Access Compliance Report

Public Rights-of-Way

Intersection ID: 3514	Main Street: OVERLOOK_MOUNTAIN_DR	Cross Street: TRANQUILLITY_DR	Location: E
ADA ID: 3D5300FC2228	Ramp Type: BlendTrans1	Initial Pass/Fail: Pass	Overall Compliance: No
Severity Score: 0			
Codes/Mitigation Info/Possible Solution		Field Measurements/Component Compliance

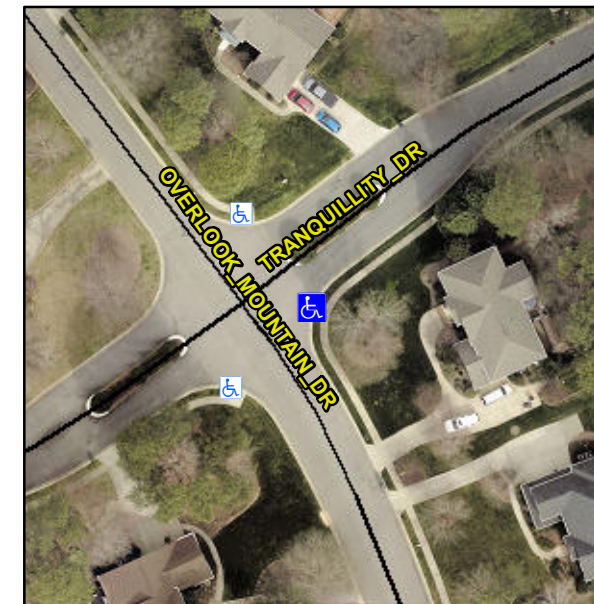
Not Found, R304.2.1, R304.2.2-Perp, R304.3.2-Para, R305.2

Remove & Replace Curb Ramp With Two New Directional Ramps or Equivalent.
